<p><b>DESIGN DOCUMENT</b></p> <p><b>CHANGE NOTICE</b></p>	<p><b>INITIATING DOC.</b>                  TYPE: N/A                  NO. N/A</p> <hr/> <p>DCP/CCP NO 013404                  REV. 9</p>				
<p><b>ASSIGNED DISCIPLINE:</b>                  Mechanical</p>	<p><b>DOCUMENT NUMBER</b>                  M-663-00017A</p>	<table border="1" style="width:100%; border-collapse: collapse;"> <tr> <td style="width:50%; text-align: center;"><b>REV.</b> W05</td> <td style="width:50%; text-align: center;"><b>SEQ. NO.</b> 02</td> </tr> <tr> <td colspan="2" style="text-align: center;"><b>PAGE 1 OF 4</b></td> </tr> </table>	<b>REV.</b> W05	<b>SEQ. NO.</b> 02	<b>PAGE 1 OF 4</b>	
<b>REV.</b> W05	<b>SEQ. NO.</b> 02					
<b>PAGE 1 OF 4</b>						
<p><b>OTHER DOCUMENTS AFFECTED BY THIS CHANGE.</b></p> <p>None</p>						
<p><b>OTHER DDCN'S REQUIRED TO IMPLEMENT CHANGE:</b></p> <p>None</p>						
<p><b>REASON FOR CHANGE:</b></p> <p>2" pipe through penetration P135S0227 was removed by change package 013404.</p>						
<p><small>DigsigOrg 4.5 0.5</small></p> <p><b>PREPARED BY:</b> <u>Jeff Suter</u> <span style="float: right;">DATE: 01/25/2017</span></p> <p style="text-align: center;"><small>Verifier Qualific

**Sketch:**

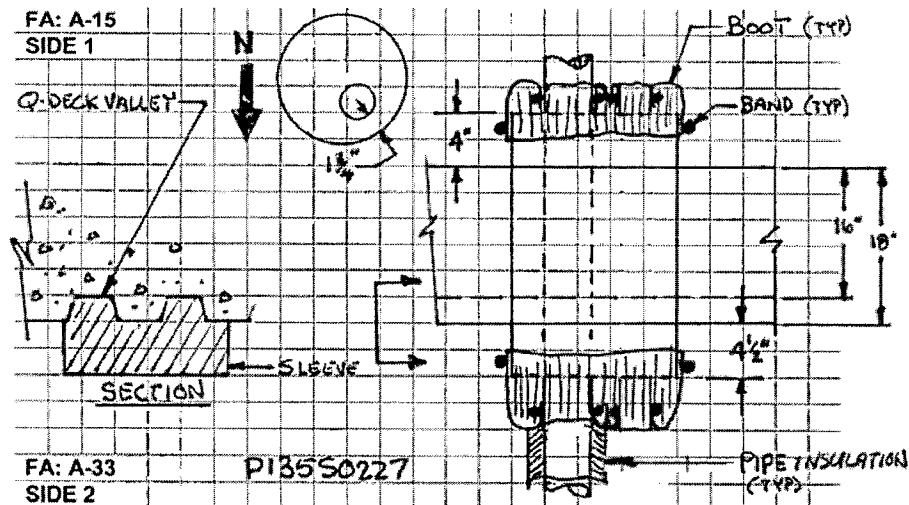
**Walkdown Comments:**

Underside of slab has Q-Decking, effective barrier thickness is measured from corrugated valley.
